Access Compliance Report

Public Rights-of-Way

Intersection ID: 44003	Main Street: FELICITY_CT	Cross Street: ELROSE_PL	Location: NE
ADA ID: 68857561D86A	Ramp Type: PerpDiag	Initial Pass/Fail: Fail	Overall Compliance: No
			Severity Score: 33.75

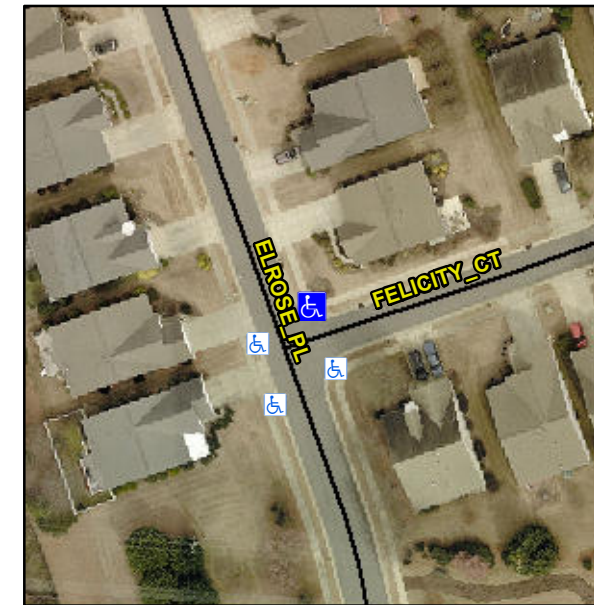
Not Found, R304.5.1, R304.5.3

Compliance	Description	Data	Compliance	Description	Data
N/A	Ramp Length (in)	47.0	Yes	Ramp Slope (%)	5.9
No	Ramp Width (in)	44.0	No	Ramp XSlope (%)	7.1
N/A	Flare Type LT	N/A	N/A	Flare Type RT	N/A
N/A	Flare Slope LT (%)	N/A	N/A	Flare Slope RT (%)	N/A
N/A	Flare Traversable LT?	N/A	N/A	Flare Traversable RT?	N/A
N/A	Landing Length (in)	N/A	N/A	DWS Provided?	N/A
N/A	Landing Width (in)	N/A	N/A	DWS Contrast?	N/A
N/A	Landing Slope (%)	N/A	N/A	DWS Length (in)	N/A
N/A	Landing X Slope (%)	N/A	N/A	DWS Full Width?	N/A
N/A	Landing Curb? (Y/N)	N/A	N/A	DWS Offset (in)	N/A
N/A	Shared Landing?	N/A			
N/A	Gutter Ponding?	N/A	N/A	Gutter Slope (%)	N/A
N/A	Gutter Lip Ht (in)	N/A	N/A	Gutter X Slope (%)	N/A
N/A	Painted X Walk1?	No	N/A	Painted X Walk2?	No
	X Walk 1 Direction	To W		X Walk 2 Direction	To S
N/A	X Walk 1 Width (in)	N/A	N/A	X Walk 2 Width (in)	N/A
	X Walk 1 Slope (%)	6.0		X Walk 2 Slope (%)	2.3
	X Walk 1 X Slope (%)	0.3		X Walk 2 X Slope (%)	8.4

Remove & Replace Curb Ramp With Two New Directional Ramps or Equivalent.
